**STATE OF HAWAII
DEPARTMENT OF TRANSPORTATION
HIGHWAYS**

**ADDENDUM NO. 2
FOR
KUHIO HIGHWAY RESURFACING
WAIKAEA BRIDGE TO MAILIHUNA ROAD
FEDERAL-AID PROJECT NO. NH-056-1(063)
DISTRICT OF KAWAIHAU
ISLAND OF KAUAI
April 27, 2023**

This Addendum makes the following amendments to the Bid Documents:

FED. ROAD DIST. NO.	STATE	FED. AID PROJ. NO.	FISCAL YEAR	SHEET NO.	TOTAL SHEETS
HAWAII	HAW.	NH-056-1(063)	2023	ADD.12	43

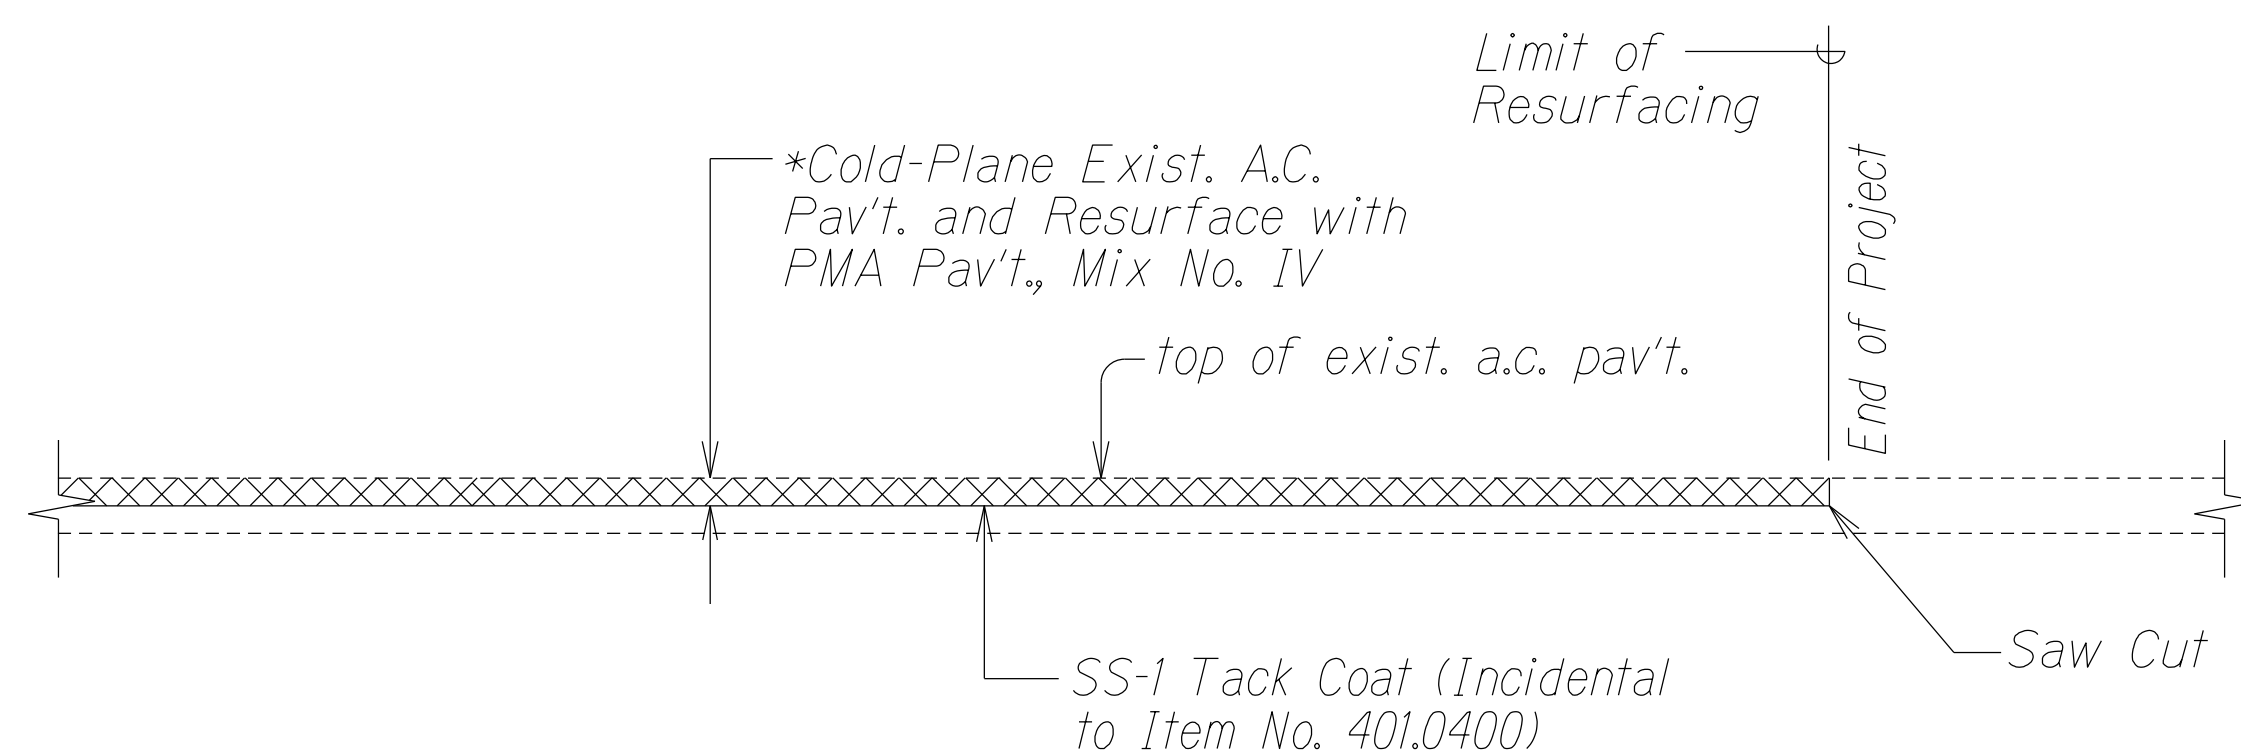
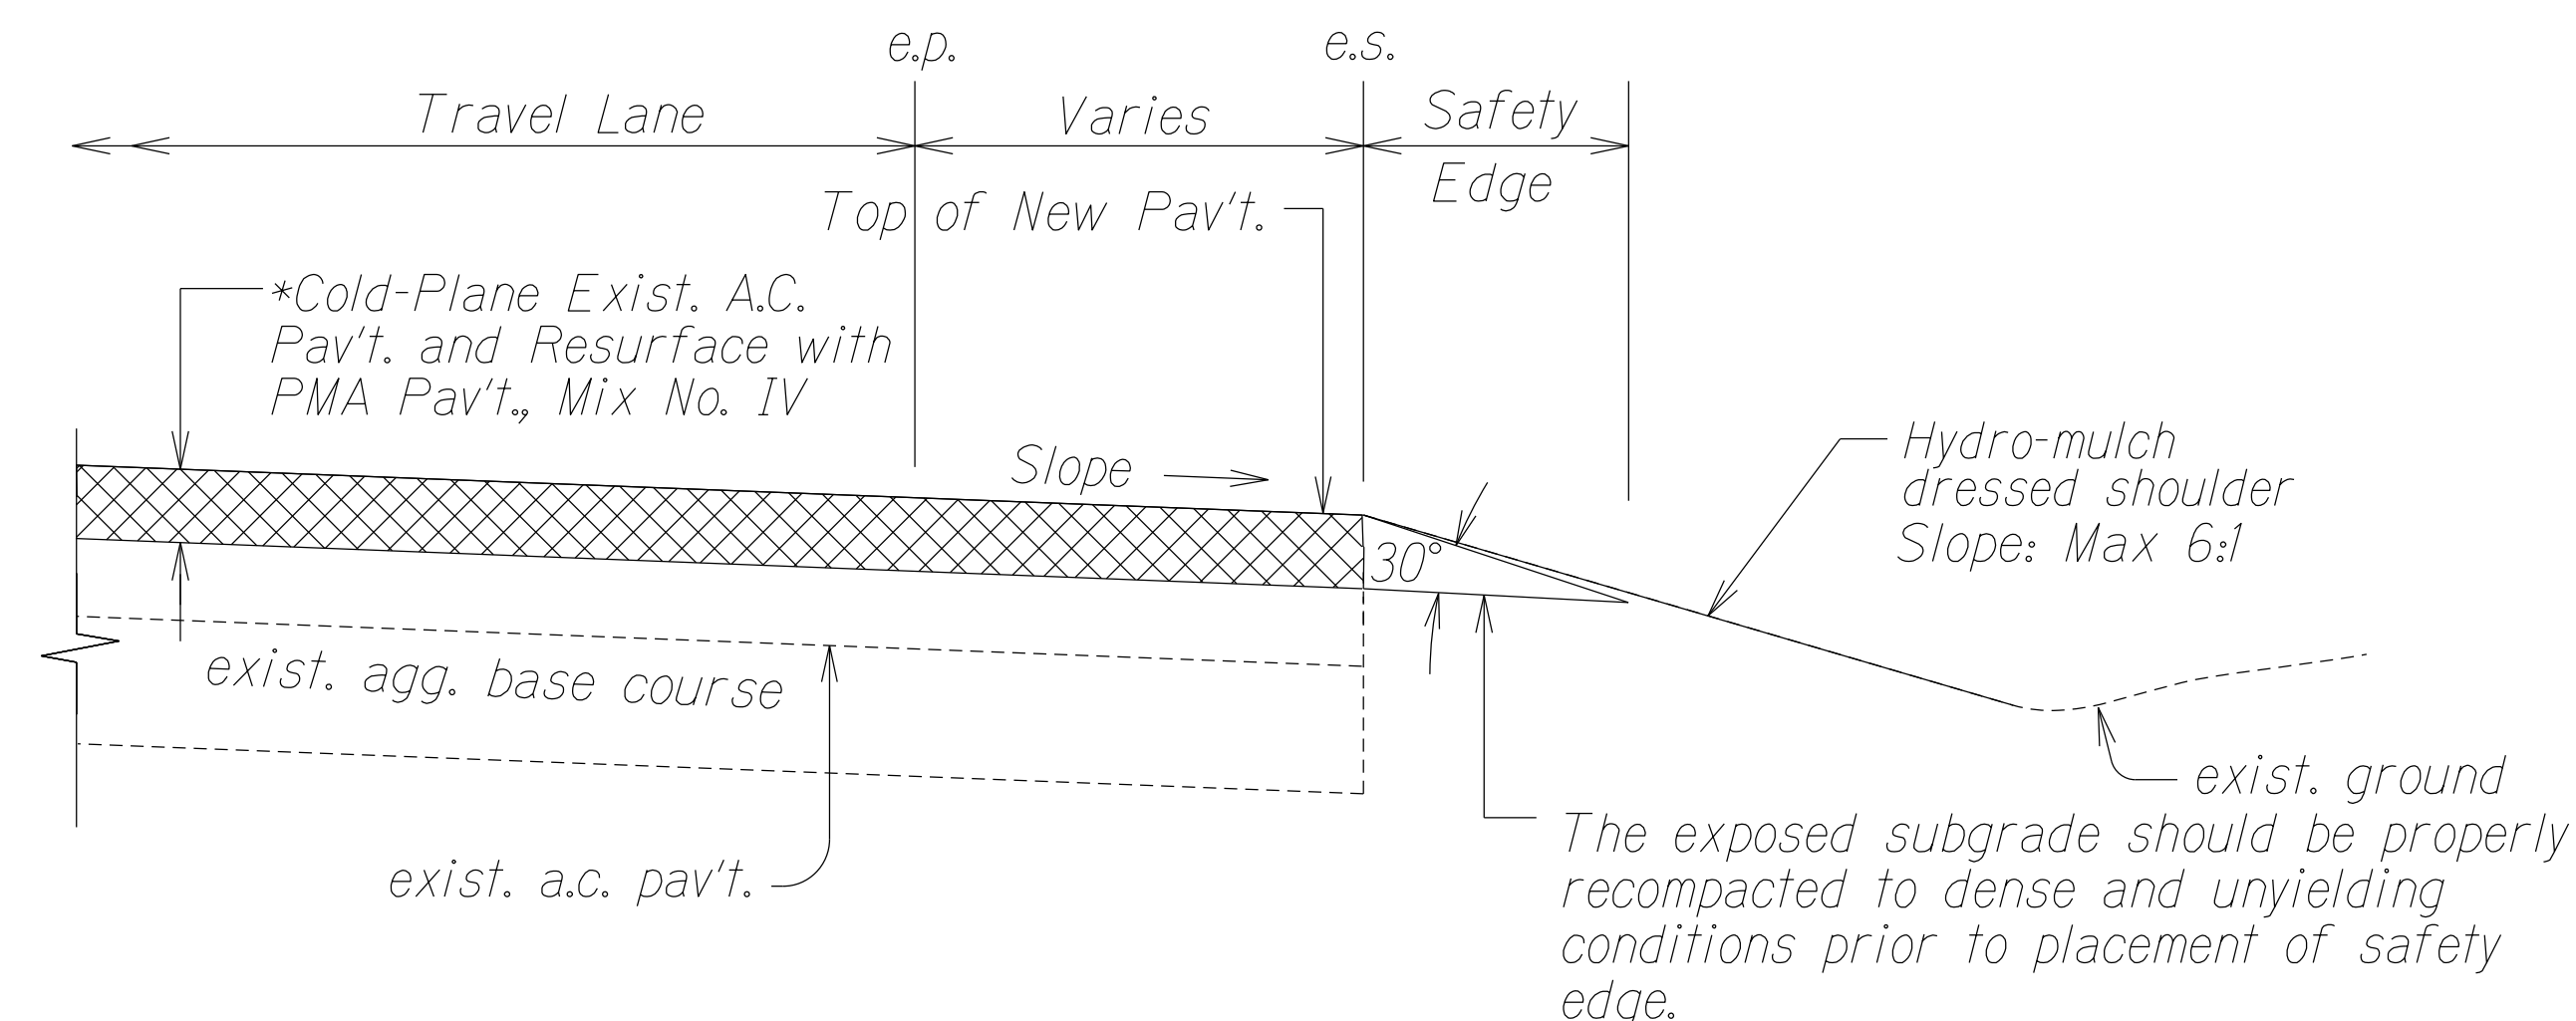
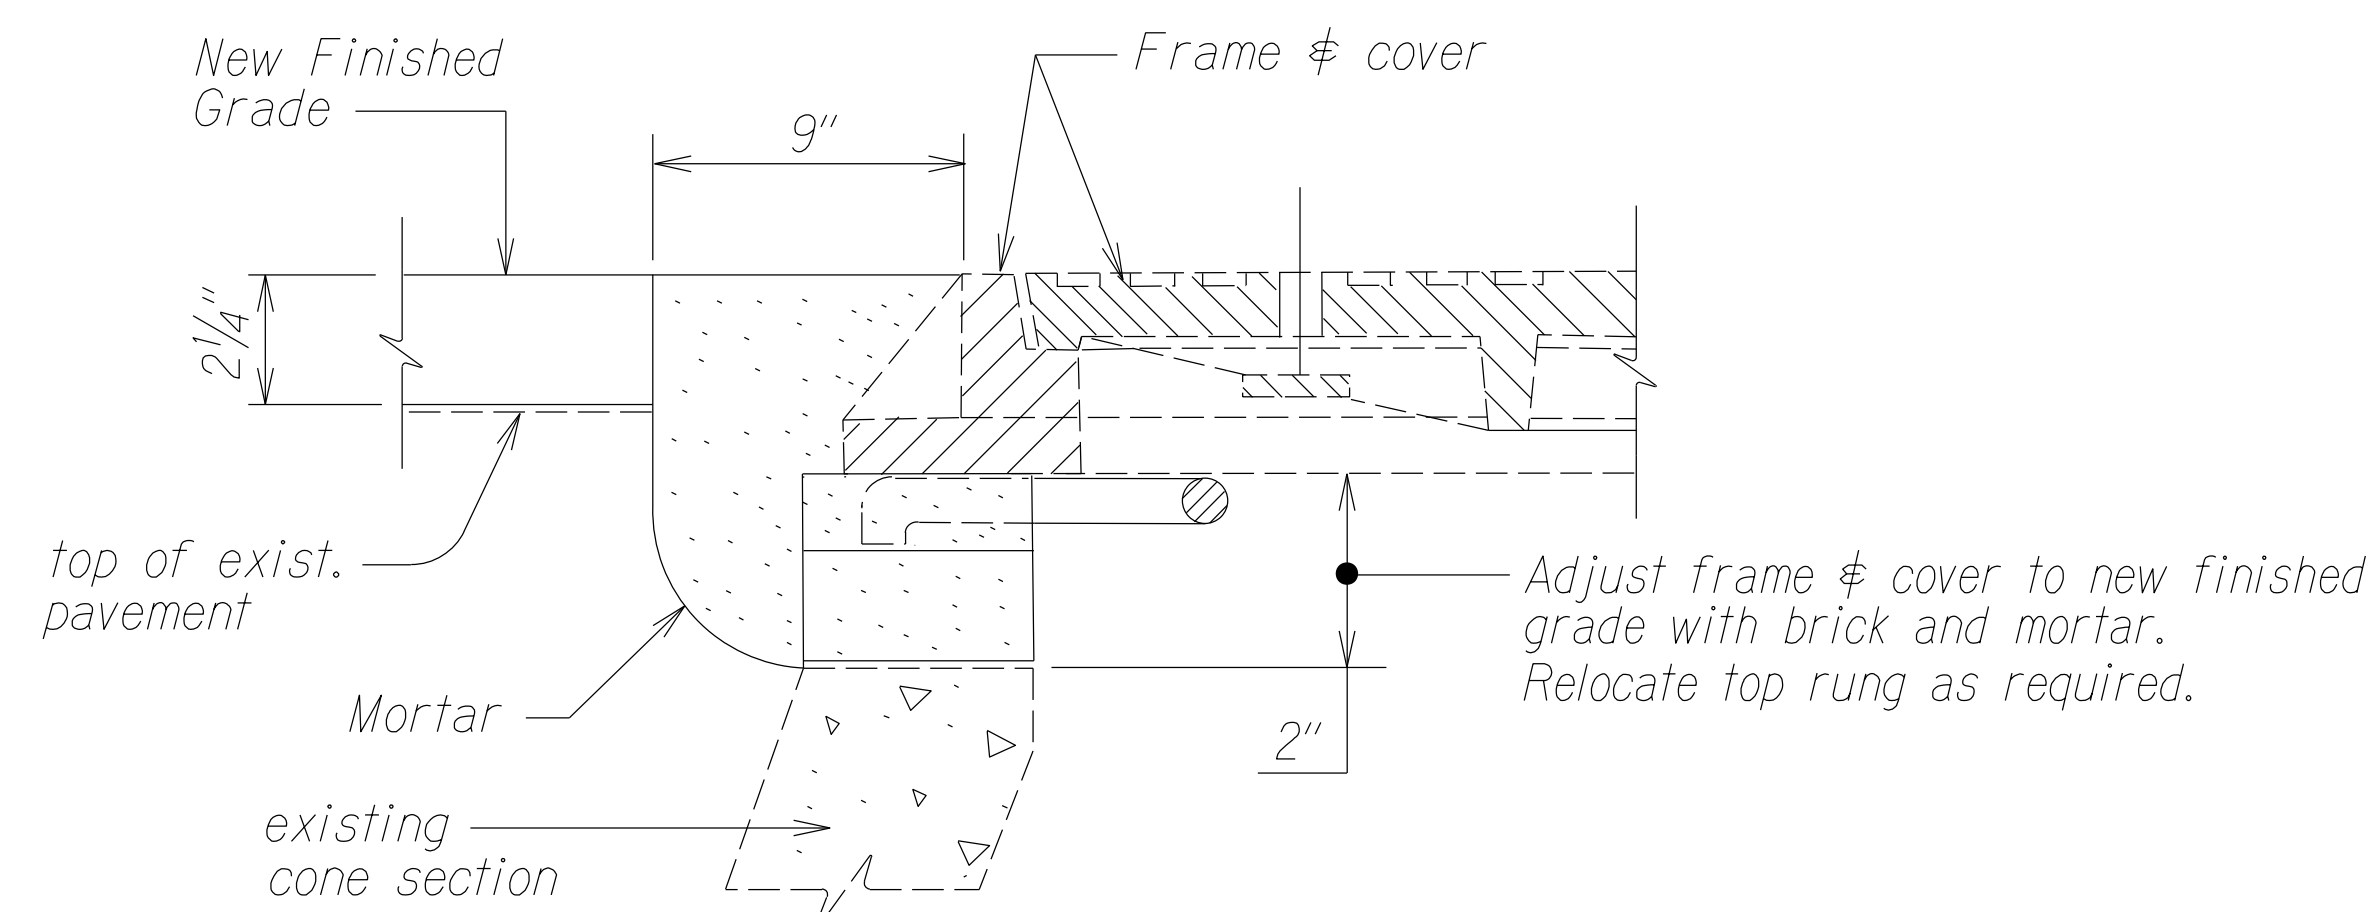
4/21/23	△ - Revise Typical Pavement Edge Detail
4/21/23	△ - Additional Notes
DATE	REVISION
STATE OF HAWAII DEPARTMENT OF TRANSPORTATION HIGHWAYS DIVISION	
<u>TYPICAL SECTIONS</u>	
KUHIO HIGHWAY RESURFACING Waikaea Bridge to Mailihuna Road Federal-Aid Project No. NH-056-1(063)	
Scale: As Noted	Date: April, 2023
SHEET No. 5 OF 5 SHEETS

TYPE A
Not to Scale

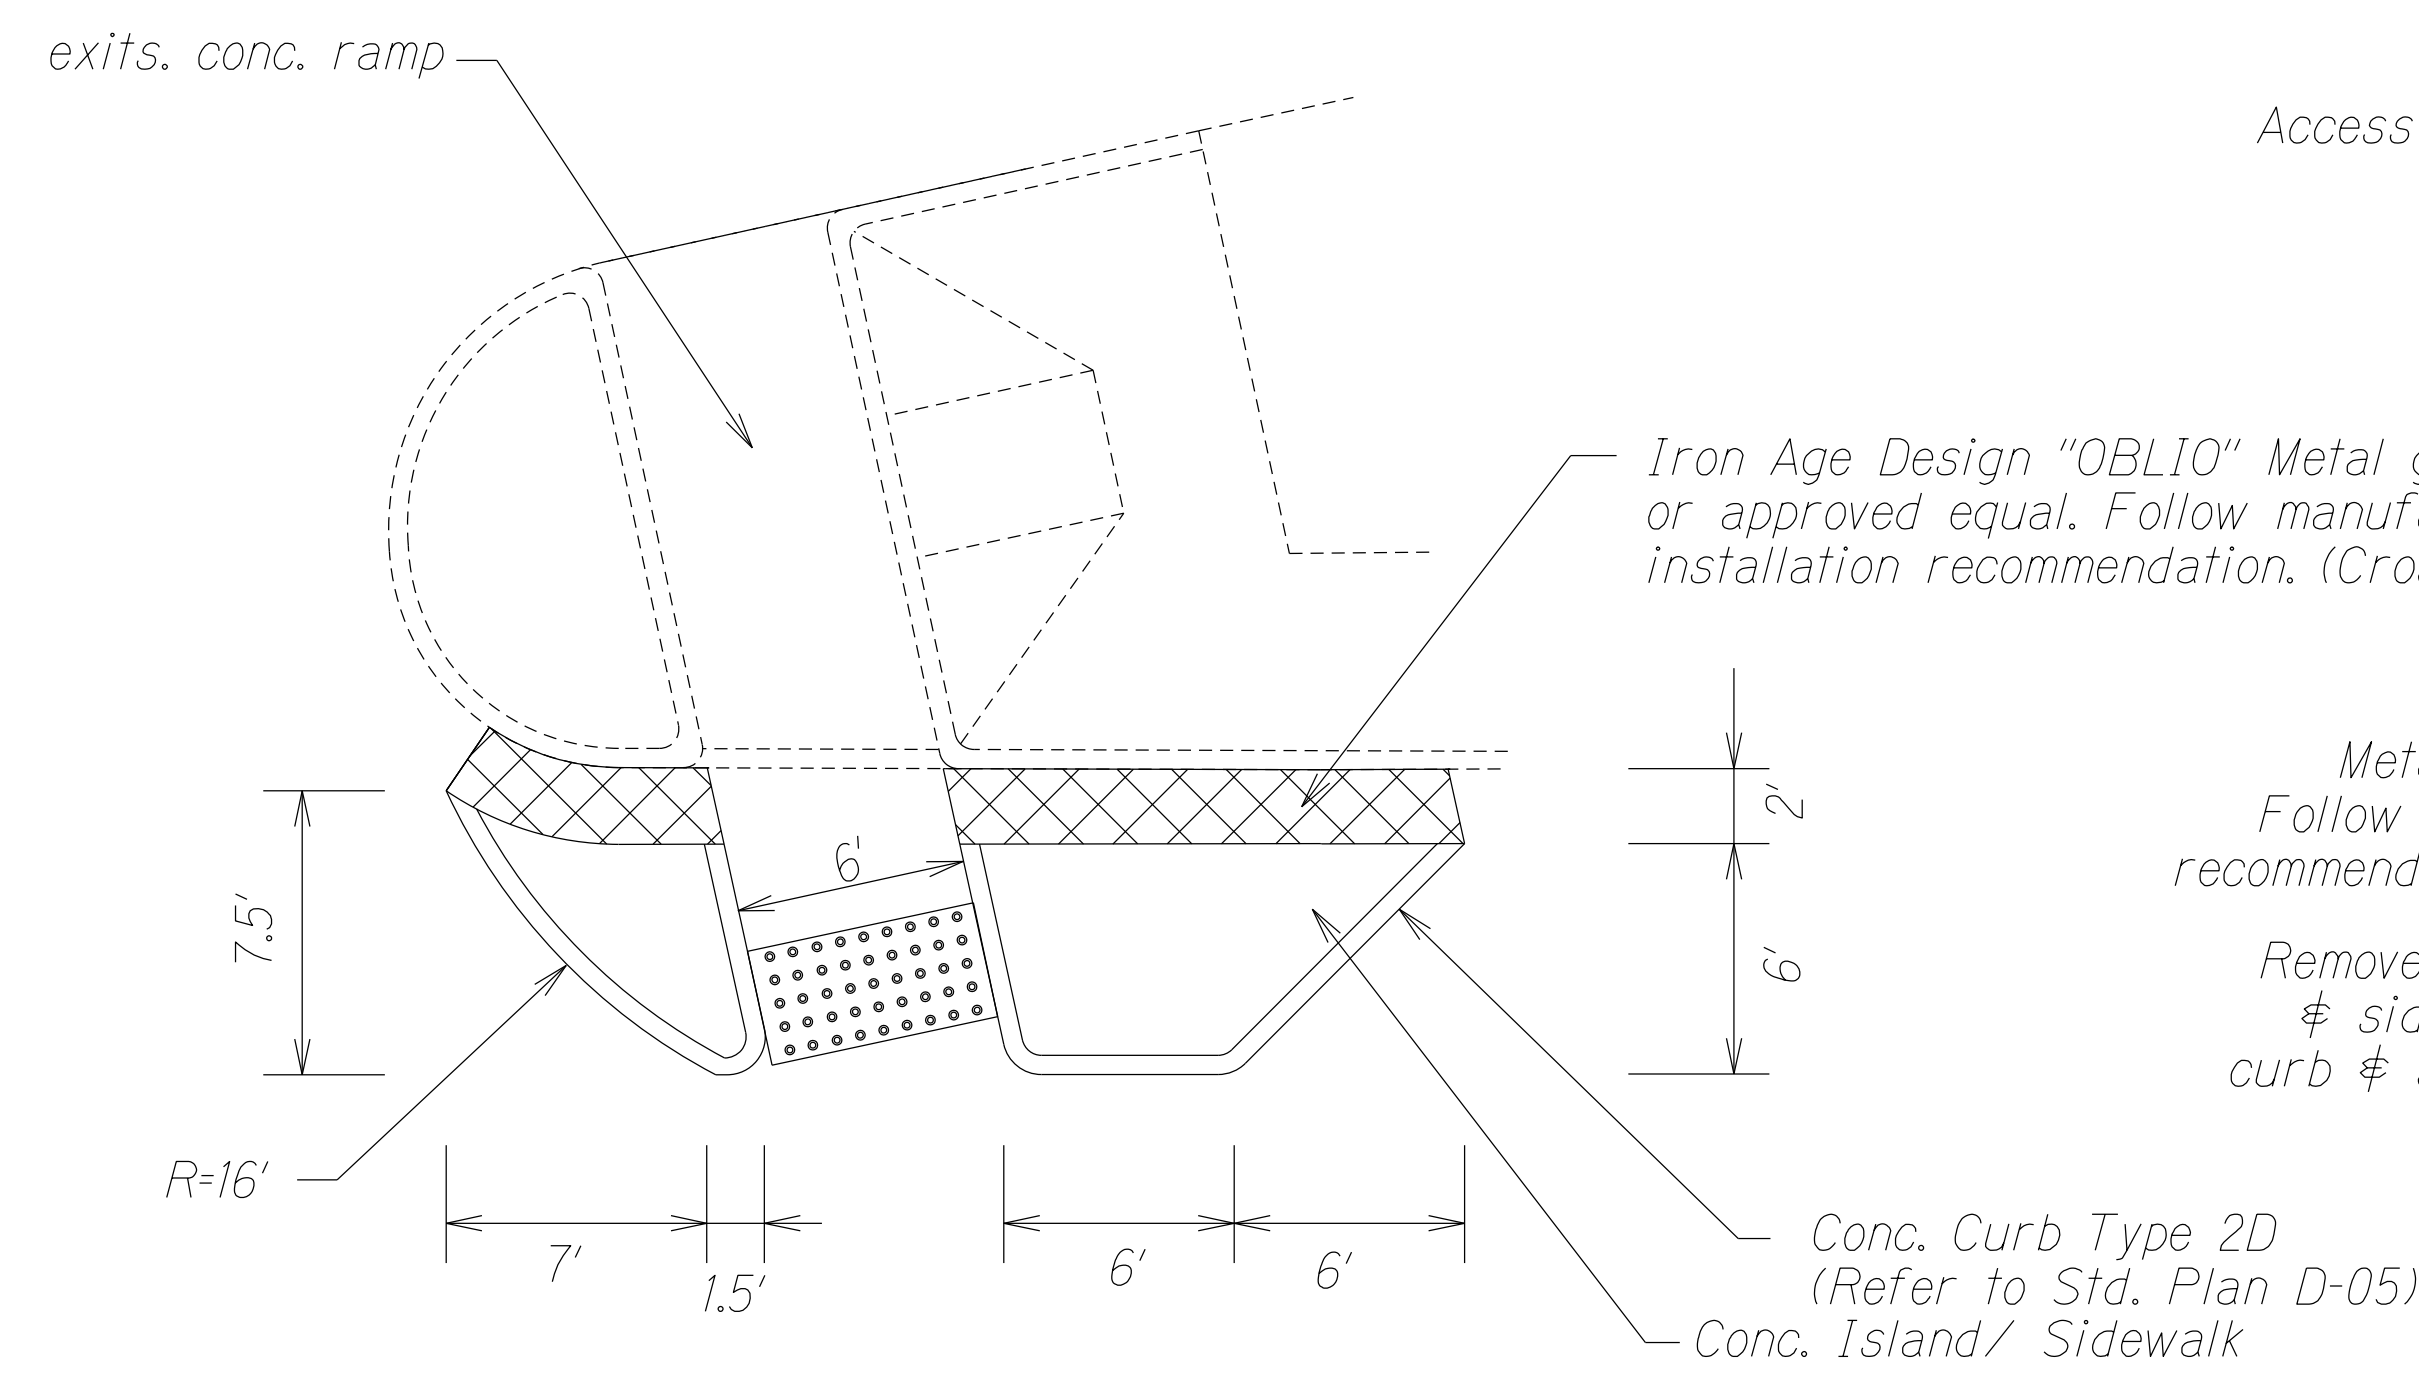
4/21/23	△ - Revise Type A Detail
DATE	REVISION
STATE OF HAWAII DEPARTMENT OF TRANSPORTATION HIGHWAYS DIVISION	
MISCELLANEOUS DETAIL	
<u>KUHIO HIGHWAY RESURFACING</u> Waikaea Bridge to Mailihuna Road Federal-Aid Project No. NH-056-1(063)	
Scale: As Shown	Date: April 2023
SHEET No. 1 OF 2 SHEETS
